REMARKS

Anticipation Rejection Based on U.S. Patent Application Publication No. 2002/0060579 A1 to Haseyama et al. in View of Applicant's Admitted Prior Art (APA)

Obviousness Rejection Based on U.S. Patent No. 6,229,320 to Haseyama et al.

Fig. 16

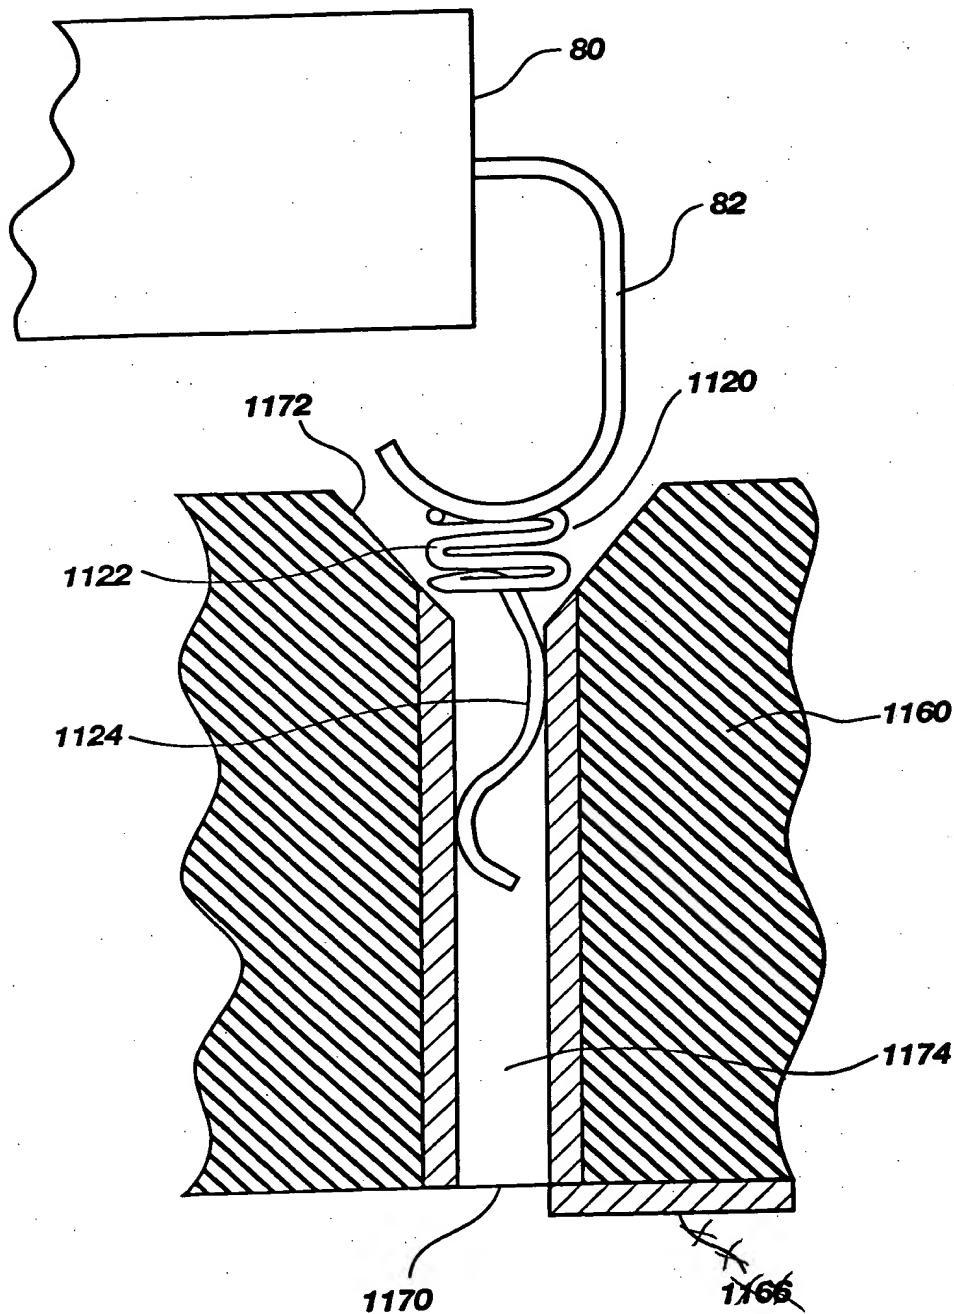
Applicant proposes to amend FIG. 16 of the drawings by deleting reference numeral "1166" and associated lead line. A copy of FIG. 16 with the proposed deletion marked in red is appended to this paper, as well as a replacement sheet with FIG. 16 as proposed to be amended.
